SUBJECT: CALVERT CLIFFS NUCLEAR POWER PLANT - NRC EXAMINATION REPORT
05000317/2008301 AND 05000318/2008301

Facility: Calvert Cliffs Nuclear Power Plant, Units 1 and 2

ER 05000317/2008301, 05000318/2008301; June 16 – August 22, 2008; Calvert Cliffs Nuclear Power Plant, Units 1 and 2; Initial Operator Licensing Examination Report.

Referencing electrical print 61076SH0031 (REACTOR SAFEGAURDS C.S. & S.I. PUMPS RECIRC VALVE 1MOV659) when 1MOV659 is shut without a corresponding RAS, contact 33/2 will open and interrupt power to the alarm circuitry and actuate the alarm.

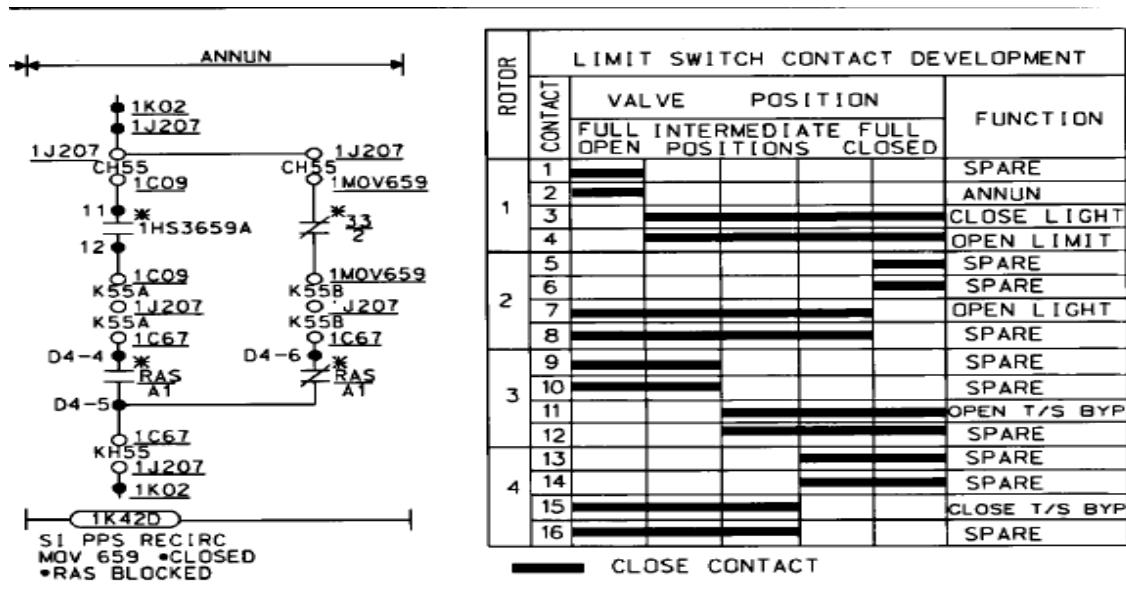
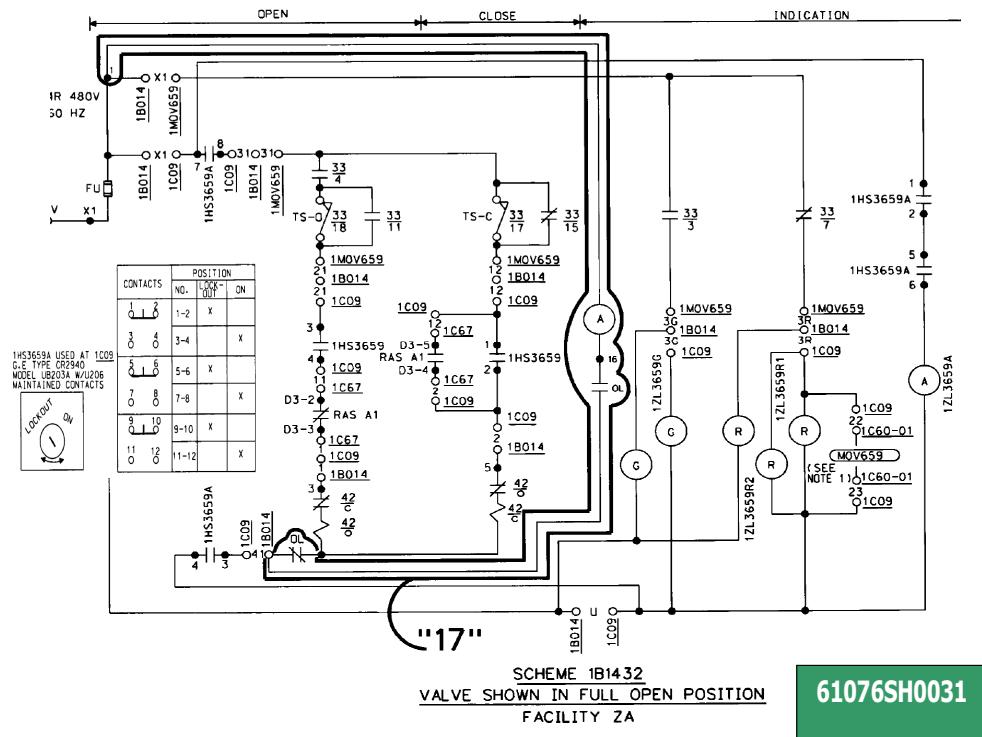
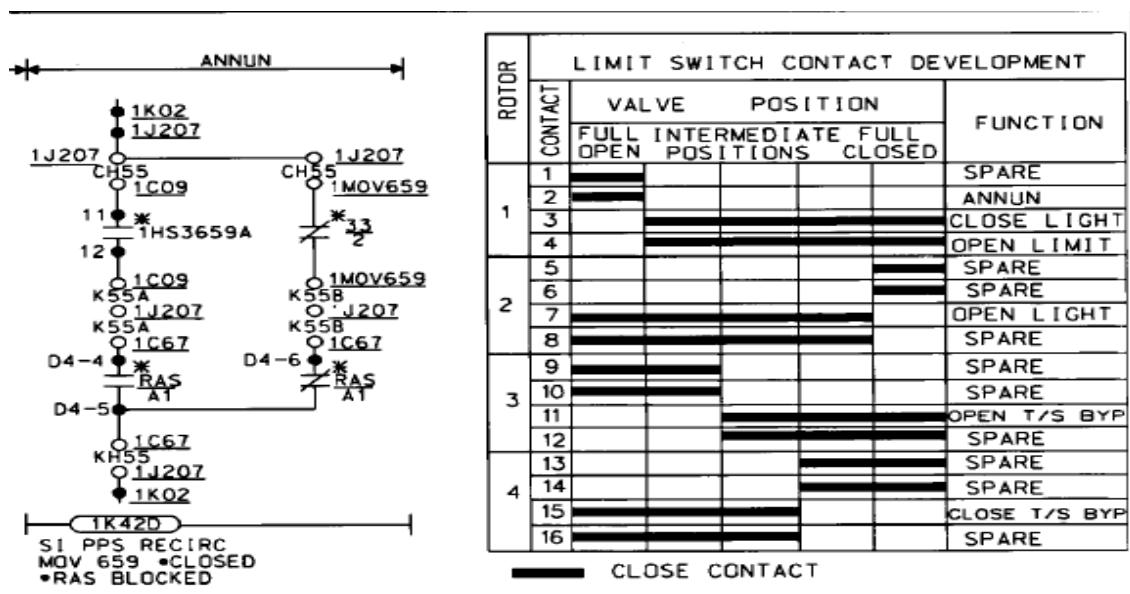
The following is the justification for changing the answer key to include selection D as a correct response in addition to selection B. Selection D states MINI FLOW RETURN TO RWT ISOL, 1-SI-659-MOV shut and SI PP RECIRC LOCKOUT handswitch, 1-HS-3659A in ON.

Selection "D" will also cause the "SI PPS RECIRC MOV 659 CLOSED RAS BLOCKED" alarm to actuate with MOV-659 shut and 1-HS-3659A in ON. The alarm circuitry logic seeks a combination of MOV 659 position, RAS actuation and 1-HS-3659A position.

Under normal configuration, 1HS3659A is in the lockout position which prevents aligning power to reposition 1MOV659. When handswitch 1HS3659A is placed in the ON position, power is aligned to 1MOV659 and the MOV is able to be repositioned by an operator. If 1HS3659A is in the ON position and an operator shuts 1MOV659 without a RAS present, contact 33/2 will open and the "SI PPS RECIRC MOV 659 CLOSED RAS BLOCKED" alarm will actuate. The electrical print shows that if 1HS3659A is placed in the ON position, contact 7 and 8 will shut and align power to 1MOV659 open/close circuitry and allow repositioning.

Based upon electrical print 61076SH0031, 1MOV659 can be shut with 1HS3659A in the ON position and satisfy the circuitry to actuate the "SI PPS RECIRC MOV 659 CLOSED RAS BLOCKED" alarm. The function of 1-HS-3659A is to supply power for positioning 1MOV-659 such as in EOP-5 when preparing for RAS actuation.

There are two correct answers. B and D should be accepted as correct responses for this question based on the electrical prints and logic diagrams.

NRC Response: The licensee contends that Choices B or D should be accepted as correct responses. The licensee's discussion above supports that Choice D is an alternate correct response. The conditions present in Choice D are 1) SI PP RECIRC LOCKOUT Handswitch 1HS-3659A in ON, 2) NO Recirculation Actuation Signal (RAS) present, and 3) 1MOV659 is CLOSED. The circuitry for the annunciator alarm (from print 61076SH0031) is shown with RAS contacts in the configuration for no RAS present. (See below.) When no RAS is present (there is no basis for the applicant to assume RAS actuation because the stem), the left branch of the alarm circuit is interrupted by the open RAS contact (from D4-4 to D4-5). The position of the in-series Lockout Handswitch contact (1HS3659A, 11-12) is immaterial as the alarm state is satisfied for the left branch when the circuit is interrupted by the absence of a RAS signal. If the MOV is closed in the no-RAS condition, the associated MOV position contact (33/2) will open, interrupting the right branch of the alarm circuit. With both circuit branches interrupted, the alarm will actuate thereby making Choice D also correct.

However, further review of this circuit logic shows that Choice A is also a correct answer. Choice A establishes conditions of 1MOV659 being closed with an inadvertent RAS present. The MOV position interrupts the right side of the alarm circuit by opening position contact 33/2. The RAS present closes a contact in the left branch (D4-4 to D4-5). The choice does not mention lockout switch position. For this choice, there is no basis for the applicant to assume other than the normal LOCKOUT position for the lockout switch since no information is provided regarding the switch. With the lockout handswitch in LOCKOUT, the left branch is also interrupted at the 11-12 contact. Likewise, with both branches interrupted, the alarm actuates.

Conclusion: The NRC disagrees with the licensee's recommendation to accept either Choice B or D as correct answers. Examination Standard ES-403 D.1.c states that "If three or more answers could be considered correct or there is no correct answer, the question shall be deleted." Because there are three correct choices (A, B, and D) the question will be deleted.

61076SH0011D

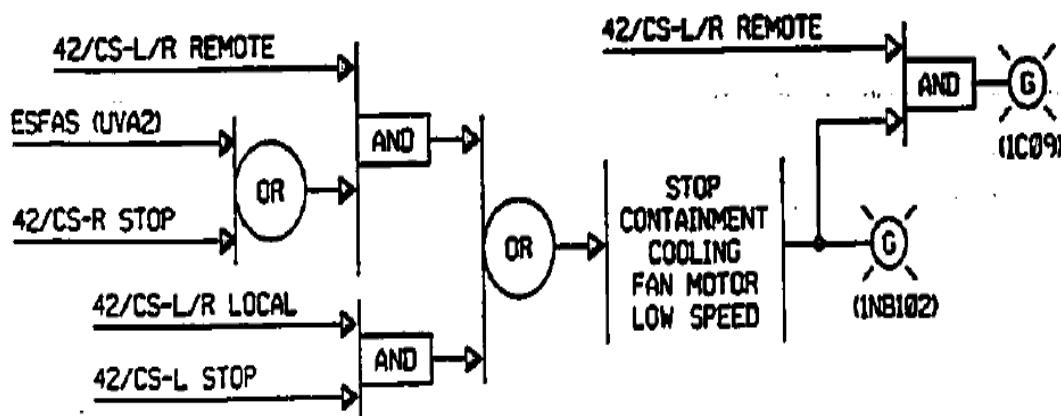
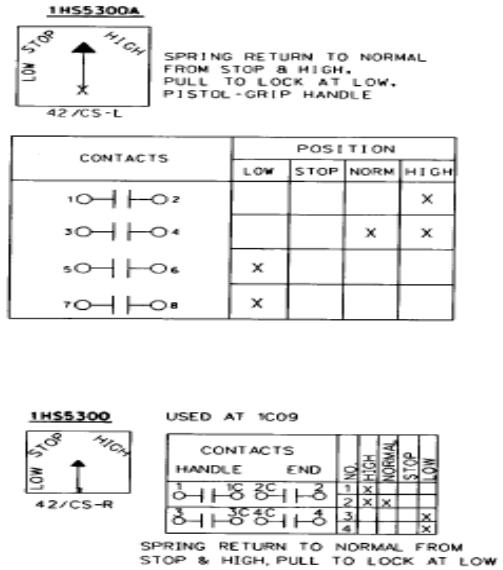
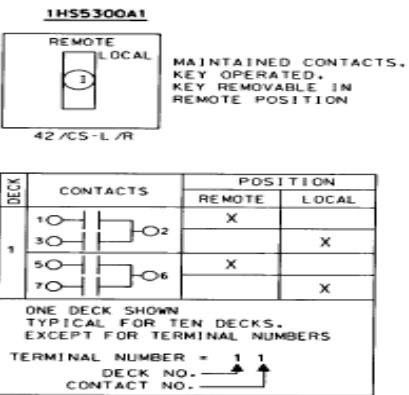
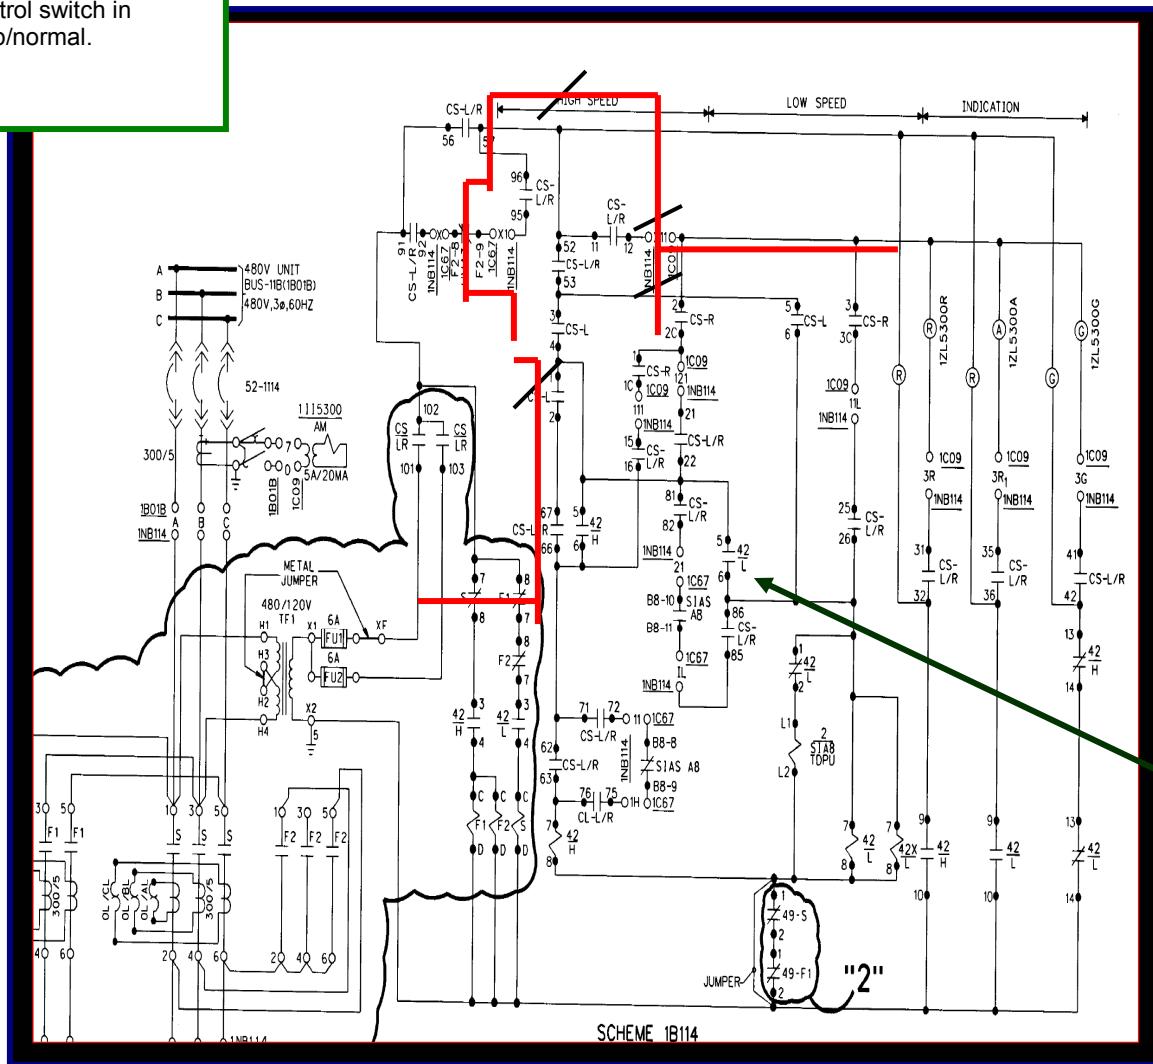
Selection C is also a correct response. The following is the justification for changing the examination answer key to include selection C as a correct response in addition to selection B. Question #40 states the following: A SIAS has occurred on Unit 1. Which of the following is a correct statement for Containment Air Cooler (CAC) operation?

Selection C states the following: The CACs can be stopped from the load contactor panel ONLY. If the CAC local remote handswitch is positioned to the LOCAL position and the CAC local control handswitch is selected to STOP, the CAC will stop regardless of the SIAS actuation signal.

The CAC logic diagram shows that the SIAS signal is not sealed in, preventing securing the CAC, if the remote/local handswitch is in the REMOTE position.

If the remote/local selector switch is in LOCAL and the local control handswitch is selected to STOP, the CAC will stop.

Electrical schematic 61076SH0011D shows that a CAC can be stopped from its local load contactor if its local/remote switch is placed in LOCAL and its local control switch is placed in STOP then spring returned to NORMAL. In this configuration the CAC can be shifted to Fast or Slow Speed locally in addition to being secured during an active SIAS.

The trace with the red lines display the control circuit's contact alignment with the local/remote switch in local and the local control switch in stop/normal.

In this control circuit configuration, power is not supplied to the SIAS A8 contact if shut.

C and B should be accepted as correct answers.

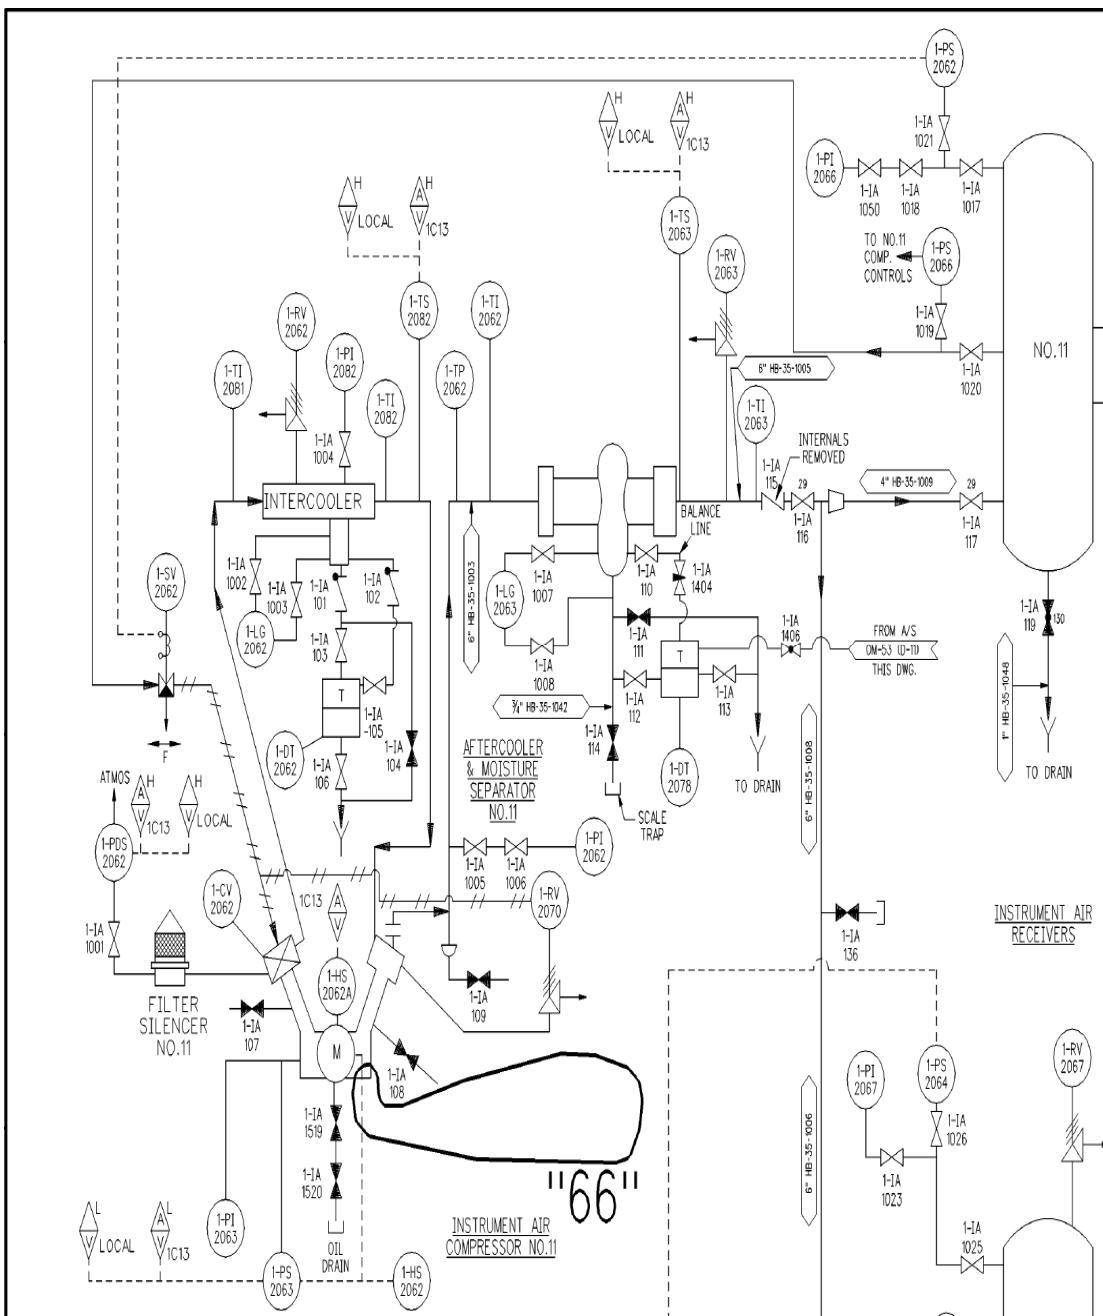
There is no correct answer. A candidate cannot determine if an instrument air system event has occurred solely upon 96 psig system pressure. This can be an expected condition since the instrument air compressors can cycle between 95 psig and 106 psig. Per the set point file (Attachment 1) for the Compressed Air System, pressure switches 1-PS-2062 and 1-PS-2064 cycle 11 and 12 Instrument Air Compressors between 97 and 104 psig +/- 1.86 psig to regulate instrument air system pressure.

The drawing below shows that 1-PS-2062 monitors 11 Instrument Air Receiver pressure and cycles 11 Instrument Air Compressor between the set points.

The alarm referenced in the answer explanation (INSTR AIR SYS MALFUNCTION) does not support the answer if instrument air pressure is the only parameter provided to the candidates. Indications that a loss of power to an Instrument Air Dryer cannot be based only on 96 psig instrument air system pressure. The question should have included additional data to support the correct answer.

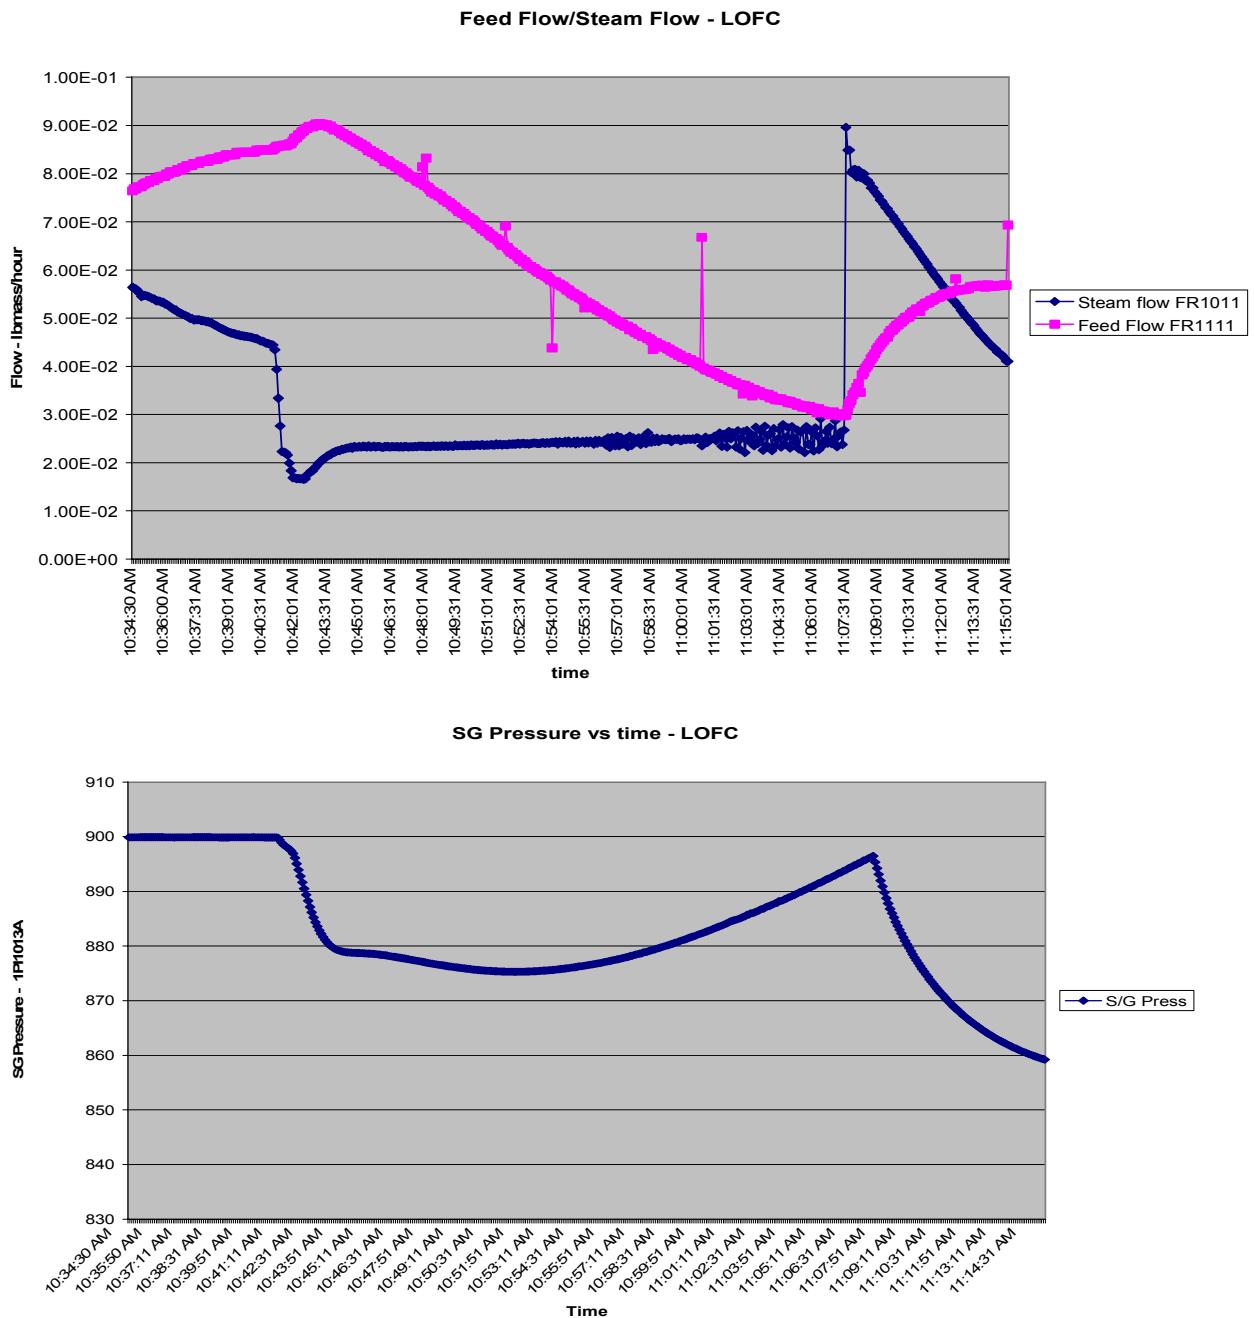
The stem of the question is confusing. Some candidates thought the question was asking for the indications of loss of forced flow, others thought the question asked for the indications of loss of natural circulation flow (based on “a loss of RCS flow is occurring” in the stem).

- Indications of a loss of forced flow after about 25 minutes are, the ADVs open, S/G pressure starts to lower as feed and steam flow rise (response B) until after the ADVs shut again.
- A loss of natural circulation flow would be indicated by S/G pressure rising while feed and steam flow lowered (response A, see simulator trends prior to ADVs opening. RCS flow would eventually stagnate, leaving a hot S/G at a higher pressure with feed and steam flow matched at a lower rate).

The original answer accepted, C, is incorrect. Steam flow and feed flow lower while S/G pressure is rising until the ADVs open. Once the ADVs open, S/G pressure lowers and feed and steam flows rise until the ADVs reshut.

D is incorrect for the time period stated. From the simulator data, feed flow would not be lowering until S/G level was greater than 0”, greater than 1 hour after loss of forced flow.

Figure 3.2.3

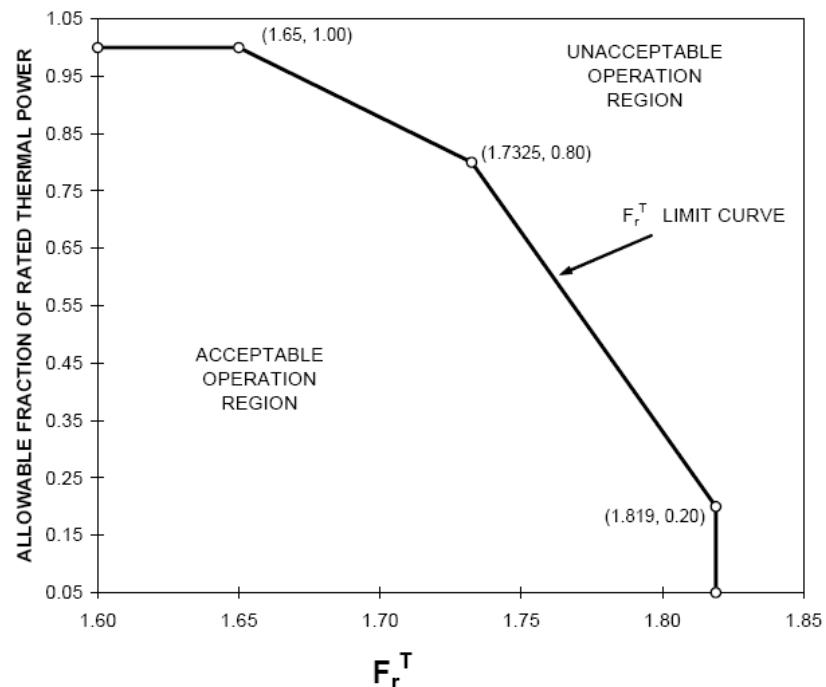
The question did not state that Special Test Exception 3.1.8 was invoked. Since no Technical Specifications were being violated, there is no reason to assume the Special Test Exception, 3.1.8 applied. At 80% power, F_{rT} can exceed the 100% power limit and not exceed the limit for 80 or 90% (See figure 3.2.3). The intent of the question was to test candidate knowledge of test exception of T.S. 3.1.8. The PSTP-3 procedure does not specifically direct invoking the special test exception of T.S. 3.1.8. Where 3.1.8 is invoked, procedures have a step to ensure the requirements are met.

See PSTP-2 attachment 3 as an example. No similar document exists in PSTP-3. The stem of the question should have stated that the special test exception had been invoked. Since the special test exception was not applicable, maintaining power stable at 90% would be the correct response. There would be no reason to subject the plant to an additional transient.

The question indicated that “At 80% power it was determined that F_{rT} is greater than the full power value of T.S. 3.2.3.” When the question was developed, the author and examiners concluded that if the value for F_{rT} exceeded the 100% power limit that it would have also exceeded the 80% and 90% power limits. However, the licensee correctly states, based upon COLR Figure 3.2.3 above, that at 80% power, F_{rT} can exceed the 100% power limit and not exceed the limit for 80 or 90% because it is a flux ratio, not an absolute value. F_{rT} would have to exceed 1.7325 in order for tech spec 3.2.3 to apply at 80%. At 100% power, F_{rT} would only have to exceed 1.65 in order to have exceeded the “full power value of T.S. 3.2.3”. Thus, with the plant at 90% power, T.S. 3.2.3 may or may not be exceeded depending upon the value of F_{rT} . Since no value was provided for F_{rT} , nor was Figure 3.2.3 provided, it was impossible to answer the question from the information given.
